ADDENDUM NO. 2

DATE: July 11, 2023
FROM: Village of Villa Park Public Works Department
TO: All Plan Holders
PROJECT: **2023 Rebuild Illinois Resurfacing Project**

TYPICAL SECTIONS

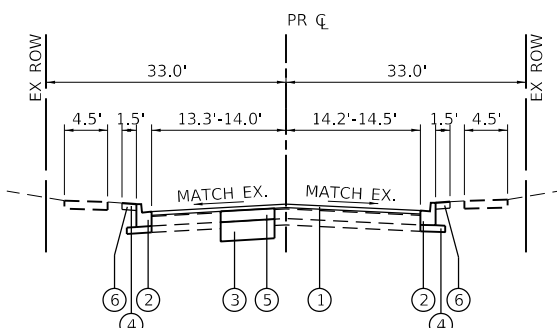
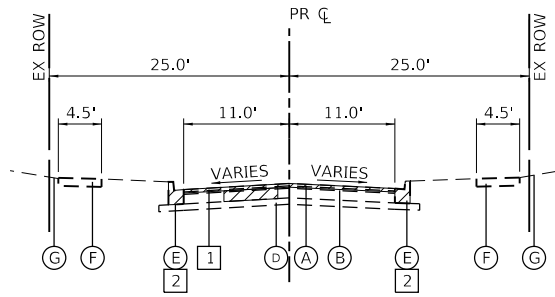
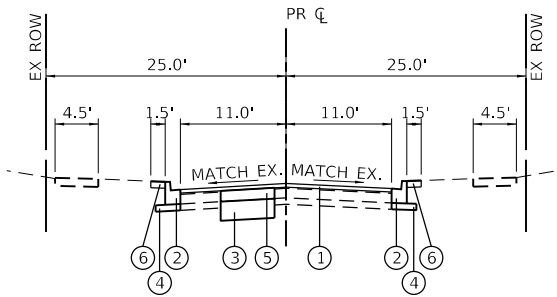
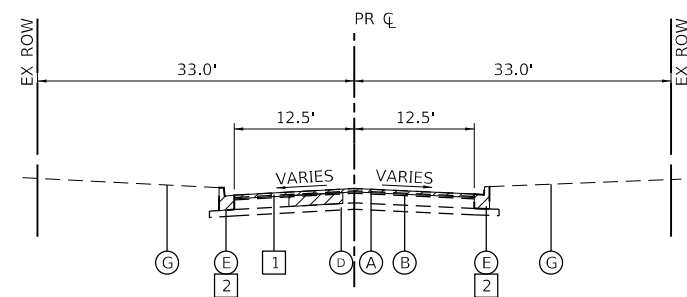
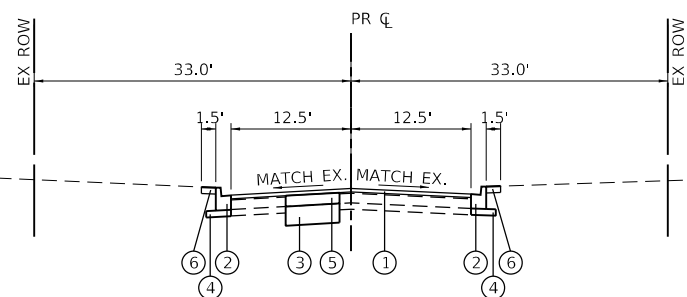
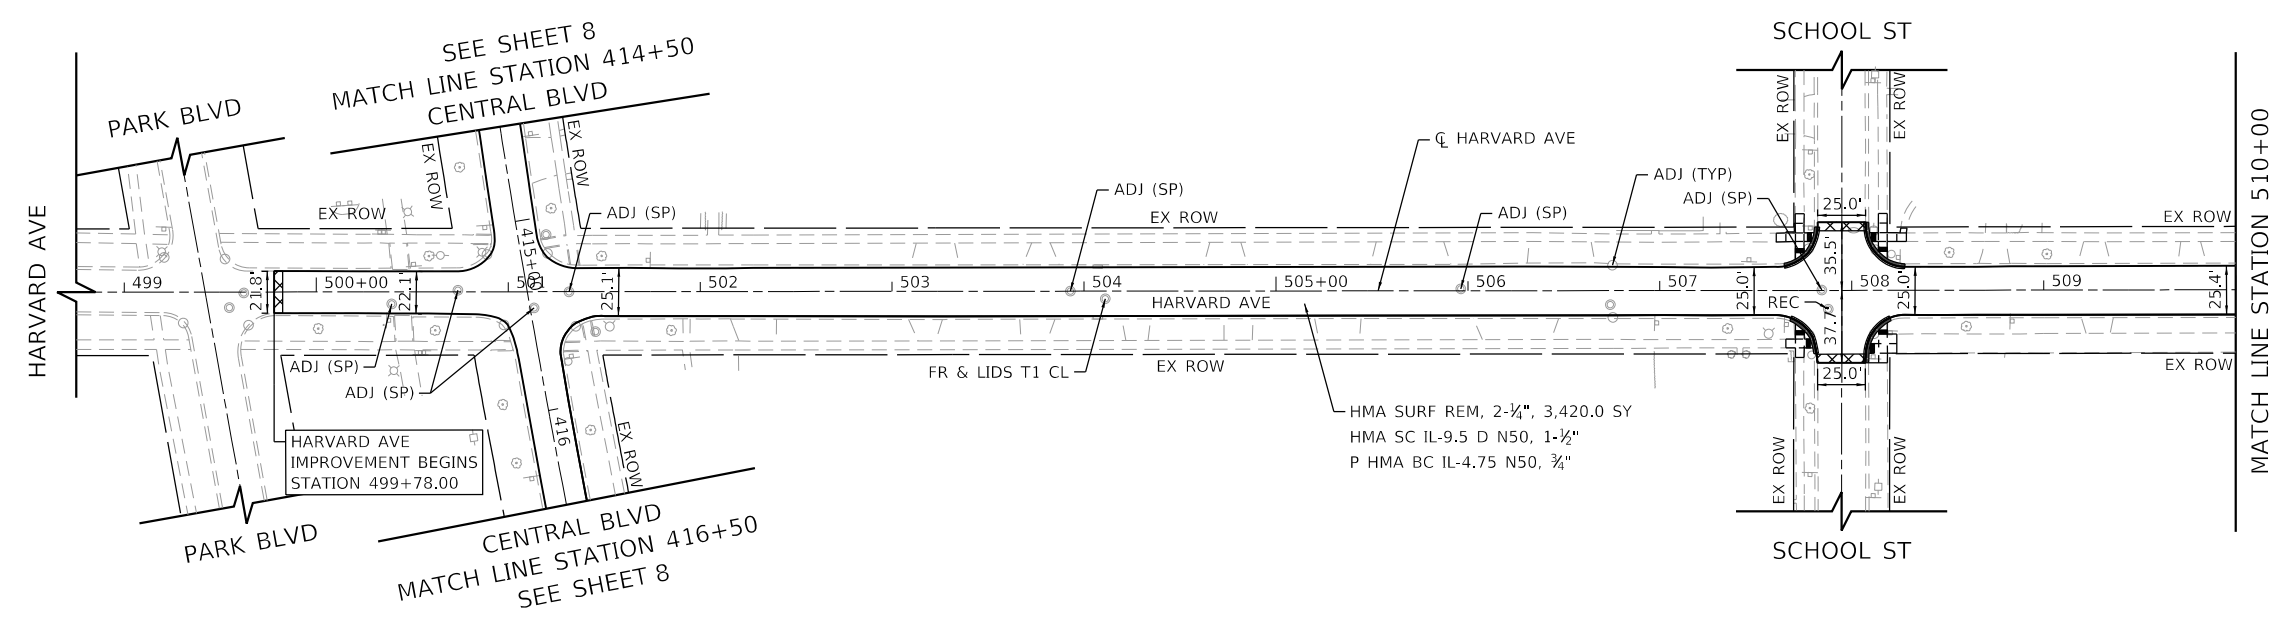
- i. Delete and replace pages 47 and 48 of the specifications with the attached version.
- c. There were inconsistencies in the Hot-Mix Asphalt mixture requirements. The project is based on a completion date of 10/27/2023.

- i. Delete and replace sheet 5 of the plans with the attached version.
- d. The type and method of patching around curb replacements has been clarified

**HARVARD AVENUE RESURFACING
 ROADWAY PLAN IMPROVEMENTS**

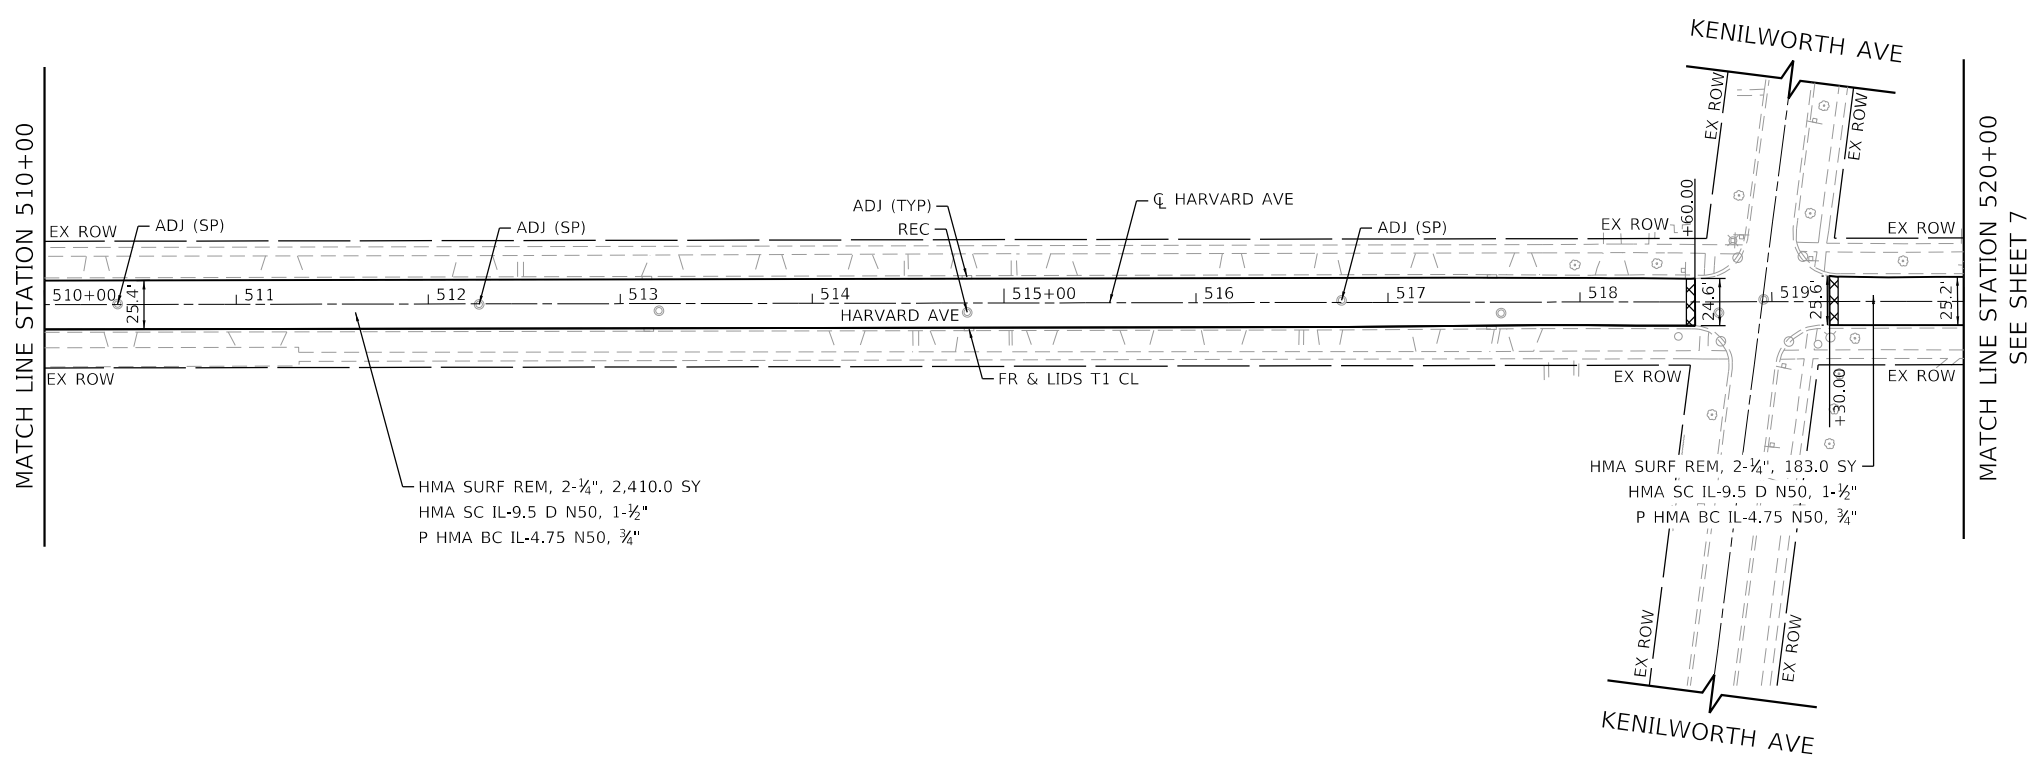
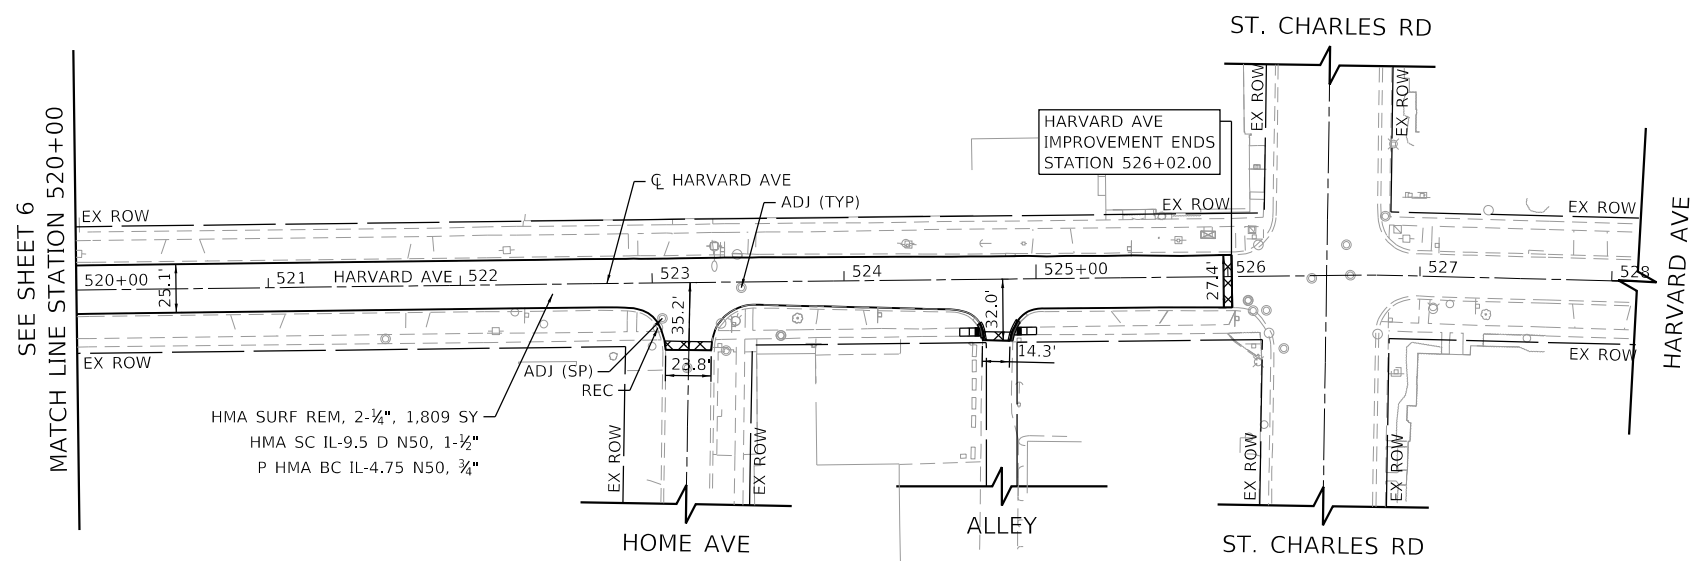
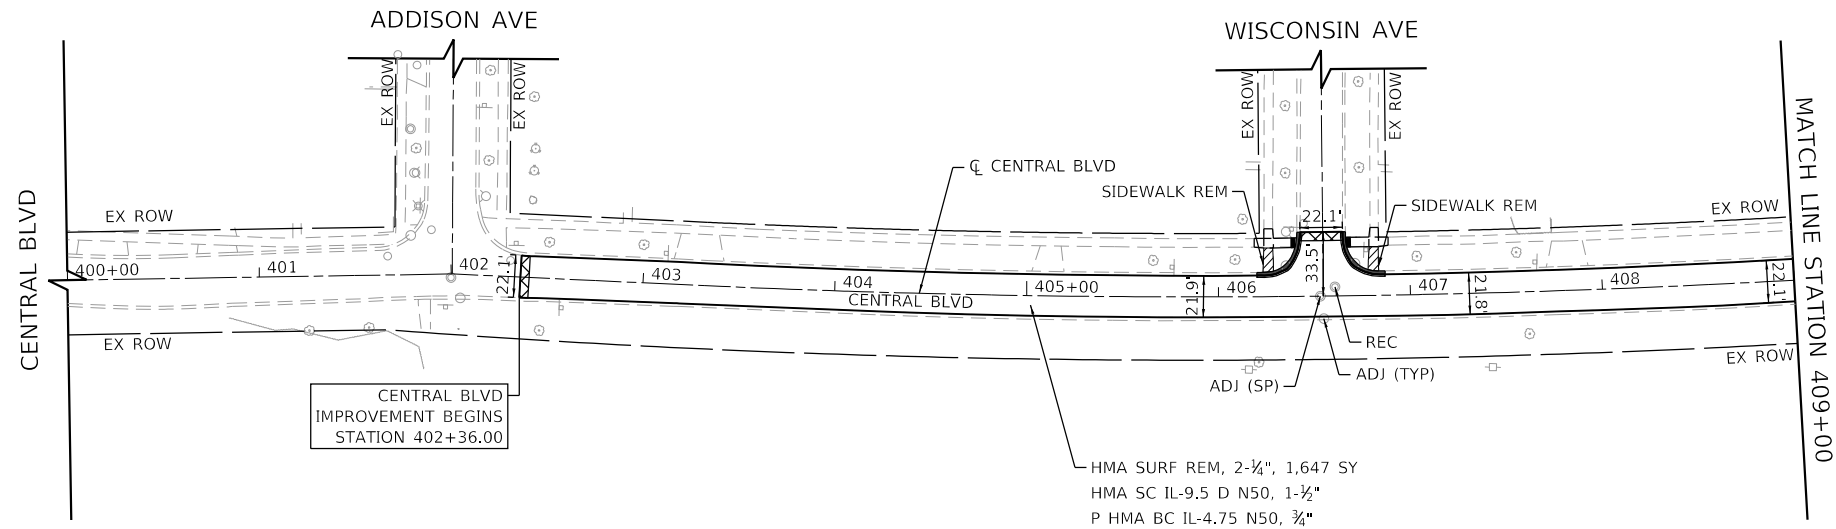
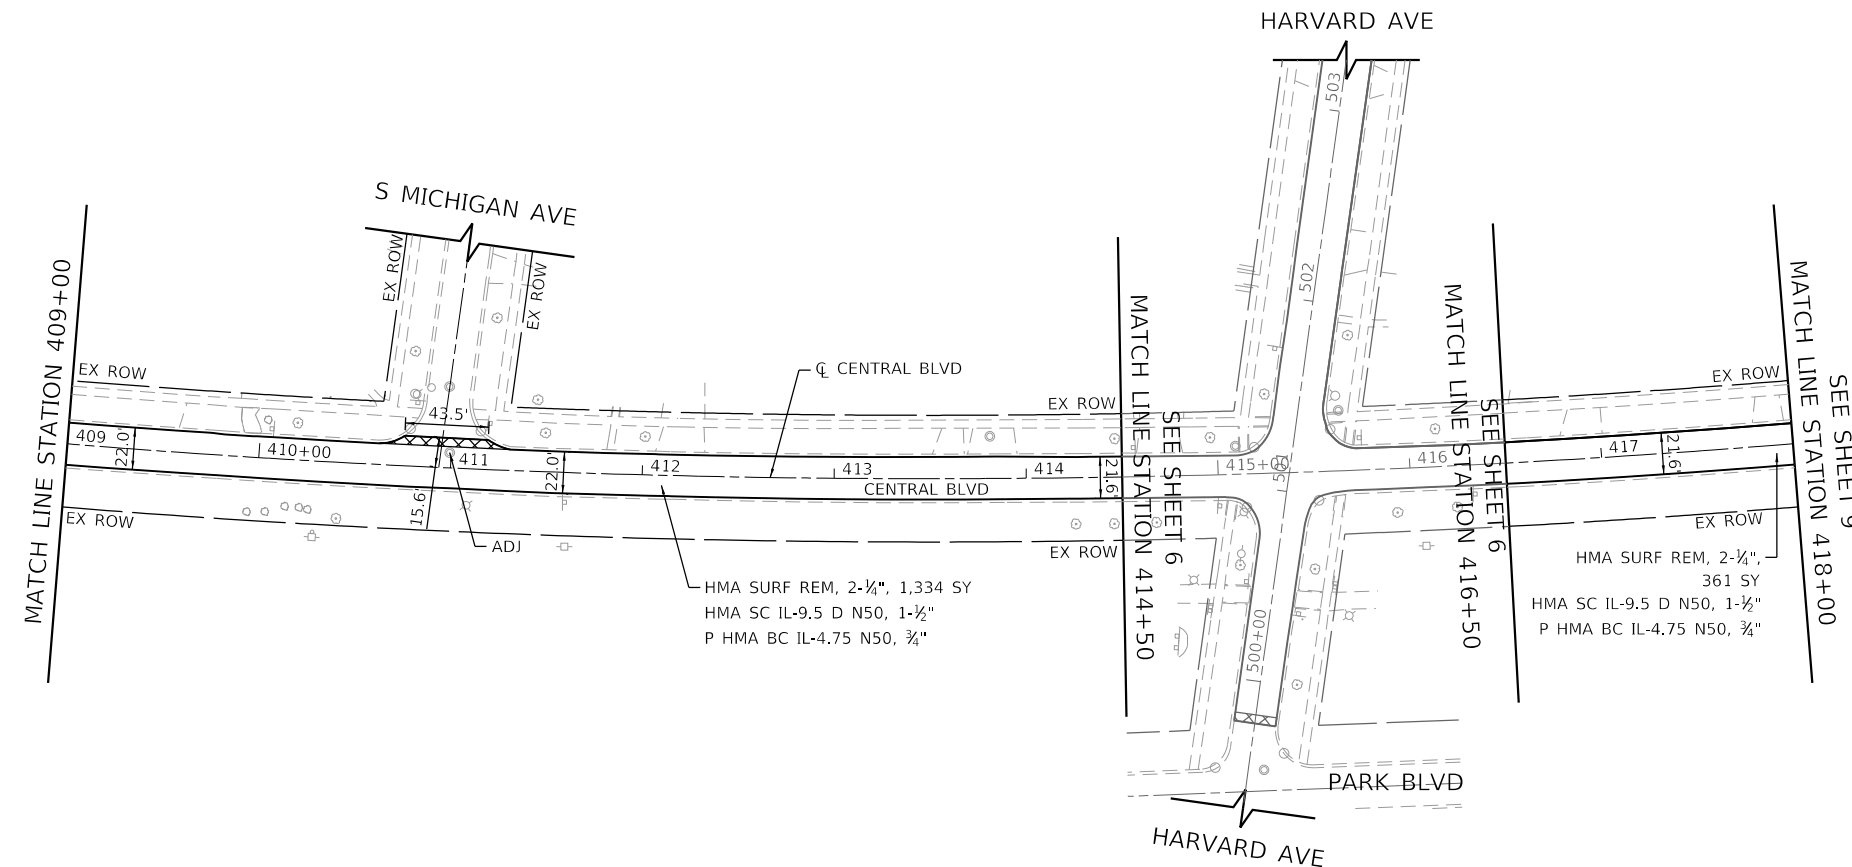
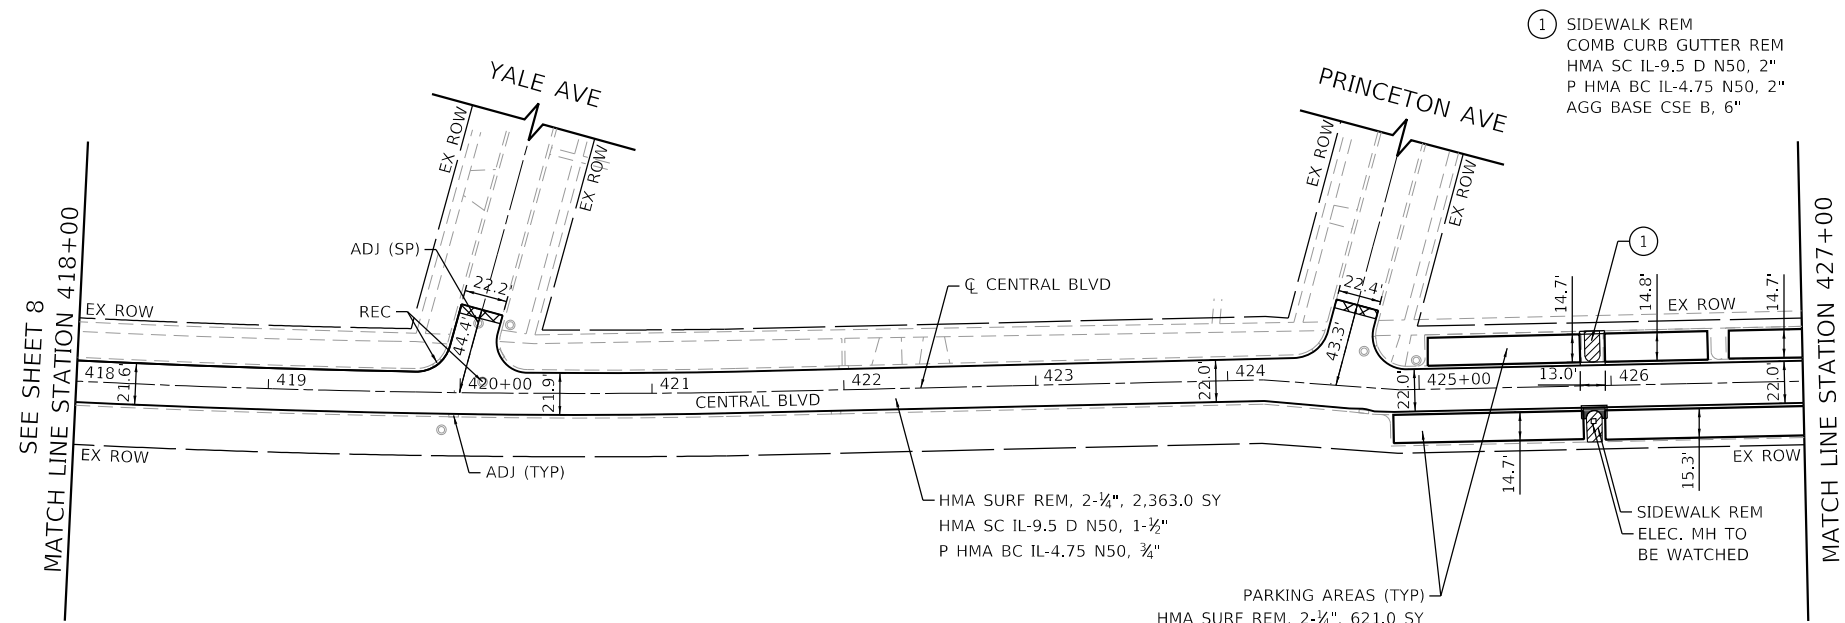
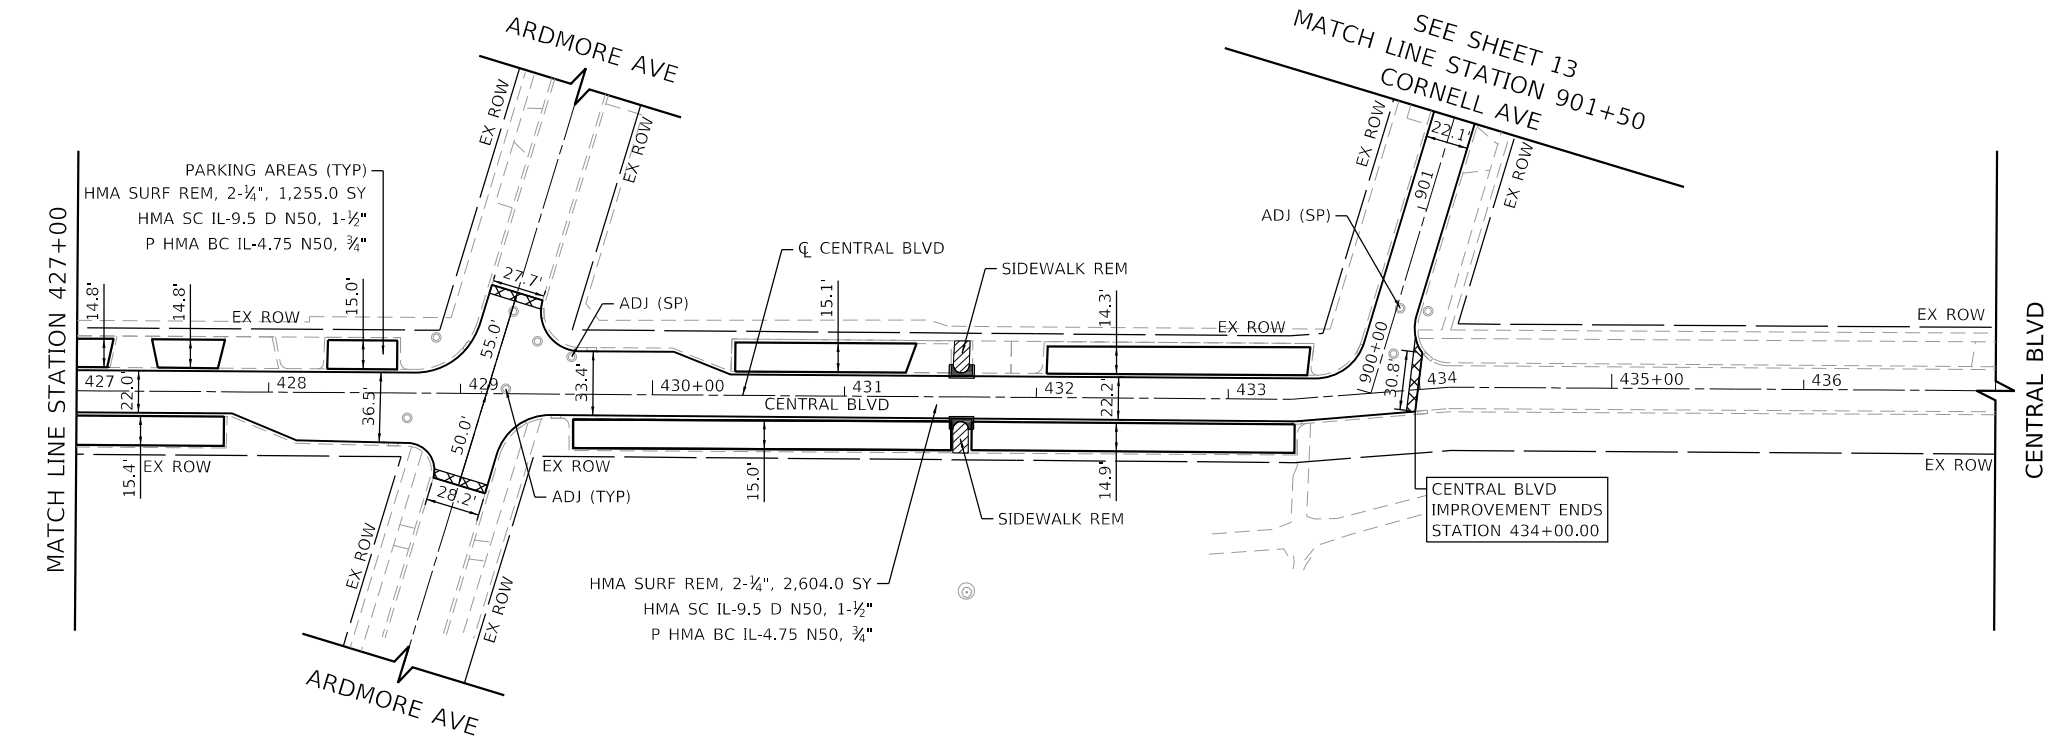
- i. Delete and replace sheets 6 through 14 of the plans with the attached versions.
